INITIAL FIRE SAFETY INSPECTION REPORT

G.A.B. Limited (Extension)

RSC ID: 26011

Date: 10 February-2025

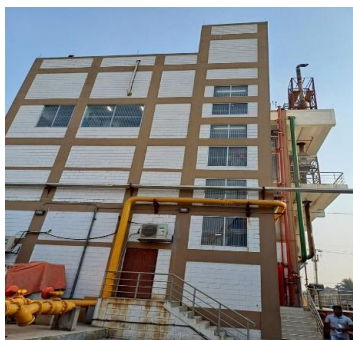
F-04	Mean of Egress	Uneven path of travel and blockage in exit discharge path due to construction purpose. Locations: On ground floor for shipment building ,Stair-1	Remove unnecessary items and level exit path to the public way. Means of egress shall be maintained continuously free , clear of all obstructions & usable to all environment.	Within 2 months
------	----------------	--	--	-----------------

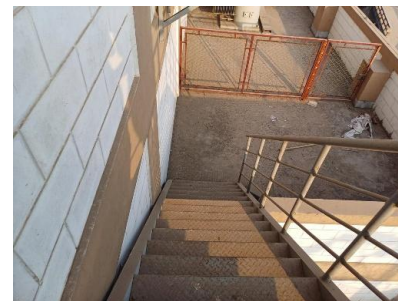
F-11	Means of Egress	Handrails are not provided on both sides of each exit stairs on all floors. Having handrails on one side of said staircase, may pose as a falling hazard during evacuation.	Provide handrails on both sides of the exit stair. New handrails shall have a minimum height of 865 mm (34 in.) and a maximum height of 965 mm (38 in.) as measured from the leading edge of the tread. Intermediate handrails shall be provided when the stair width exceeds 2.2 m (87 in.). Open guards shall have intermediate rails or pattern such that a sphere 200 mm (8 in.) in diameter cannot pass through any opening up to a height of 865 mm (34 in.). Handrail shall construct in accordance with RSC Technical Guidelines (Standard)¹ V1.0 Section 6.12.	Within 3 Months
------	-----------------	--	--	-----------------
